#### PLUG AND ABANDONMENT PROCEDURE

#### Apache #26

South Blanco Pictured Cliffs and Chacra 1850' FSL and 820' FWL, Section 13, T24N, R4W Rio Arriba County, New Mexico / API 30-039-022217 Lat: N 36.30764 Long: W -107.21474 Nad 83

#### **CONDITIONS OF APPROVAL**

### Apache #26 Proposed P&A

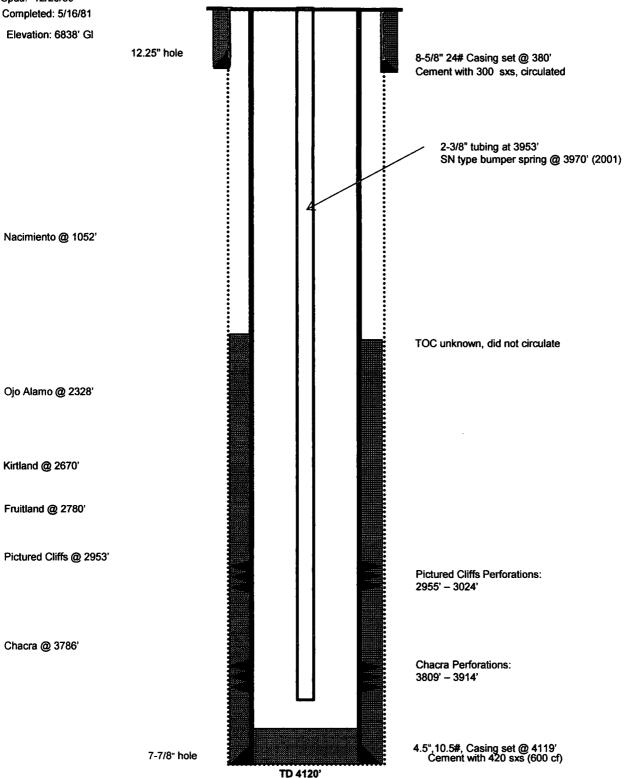
- 1. Plugging operations authorized are subject to the attached "General Requirements for Permanent Abandonment of Wells on Federal and Indian Lease."
- 2. Farmington Office is to be notified at least 24 hours before the plugging operations commence (505) 564-7750.
- 3. The following modifications to your plugging program are to be made:
  - a) Set Plug #3 (1149 1049) ft. inside/outside to cover the Nacimiento top. BLM picks top of Nacimiento at 1099 ft.

Operator must run a CBL to verify cement top. Submit the electronic copy of the log for verification to the following addresses: <u>tsalvers@blm.gov</u> <u>Brandon.Powell@state.nm.us</u>

You are also required to place cement excesses per 4.2 and 4.4 of the attached General Requirements.
